Access Compliance Report

Public Rights-of-Way

Intersection ID: 16179	Main Street: HERTFORD_RD	Cross Street: SHERWOOD_AV	Location: NE
ADA ID: C3BFAF1D25F3	Ramp Type: PerpDiag	Initial Pass/Fail: Fail	Overall Compliance: No
		Severity Score: 26.25

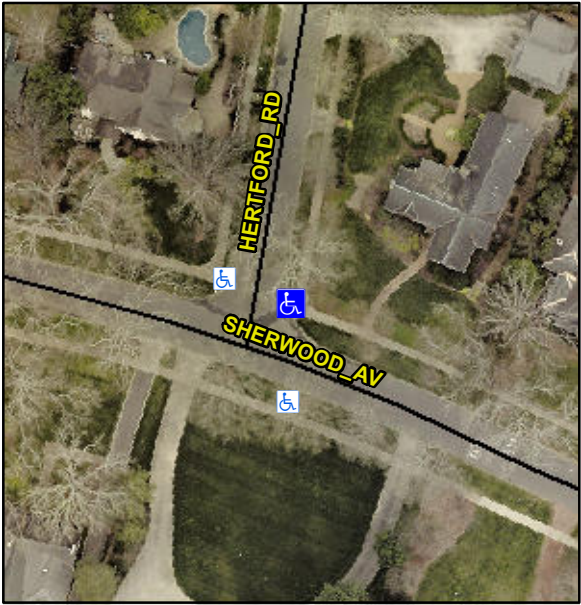
Codes/Mitigation Info/Possible Solution			Field Measurements/Component Compliance		
 <p>Street 1 Name HERTFORD RD</p> <p>Stop Condition-Street 2 StopSign</p> <p>Street 2 Name SHERWOOD AV</p> <p>Stop Condition-Street 1 None</p>	Possible Solutions:		Compliance	Description	Data
	Remove & Replace Curb Ramp With Two New Directional Ramps or Equivalent.		No	Ramp Length (in)	70.0
			Yes	Ramp Width (in)	60.0
			N/A	Flare Type LT	N/A
			N/A	Flare Slope LT (%)	N/A
			N/A	Flare Traversable LT?	N/A
			N/A	Landing Length (in)	N/A
			N/A	Landing Width (in)	N/A
			N/A	Landing Slope (%)	N/A
			N/A	Landing X Slope (%)	N/A
			N/A	Landing Curb? (Y/N)	N/A
			N/A	Shared Landing?	N/A
			N/A	Gutter Ponding?	N/A
			N/A	Gutter Lip Ht (in)	N/A
			No	Painted X Walk1?	No
				X Walk 1 Direction	To NW
			N/A	X Walk 1 Width (in)	N/A
				X Walk 1 Slope (%)	2.0
				X Walk 1 X Slope (%)	4.1
			N/A	Ramp inside XWalk1?	N/A
<p>Surveyor Notes:</p> <p>N/A</p> <p>PROW/ADA:</p> <p>Not Found, R304.2.2, R304.5.3</p> <p>Total Cost: \$ 3200.00</p>			N/A	Ramp inside XWalk2?	N/A
